This bulletin provides the procedure to replace the Canister Close Valve (CCV) on some 2012-2017MY Rio (UB) vehicles, produced from June 21, 2011 through March 28, 2016, which may exhibit the engine warning lamp DTCs P0455 and P0456 for an evaporative emission system leak due to the Canister Close Valve (CCV) stuck open. Follow the procedure outlined in this bulletin to replace the CCV with an improved part. Before conducting the procedure, verify that the vehicle is within the affected production date range.

# CANISTER CLOSE VALVE (CCV) REPLACEMENT

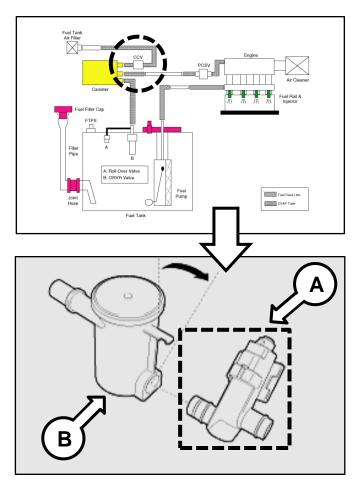
The Canister Close Valve (A) is a separate part from the Fuel Tank Air Filter assembly (B) where it is inserted.

<u>Improved CCV:</u> Rubber seal material change and port color change (black to tan) as shown.

Old CCV

New CCV

Replace the Canister Close Valve (A) by referring to the "Engine Control / Fuel System → Engine Control System → Canister Close Valve (CCV) → Repair procedures" chapter in the applicable Shop Manual on KGIS.
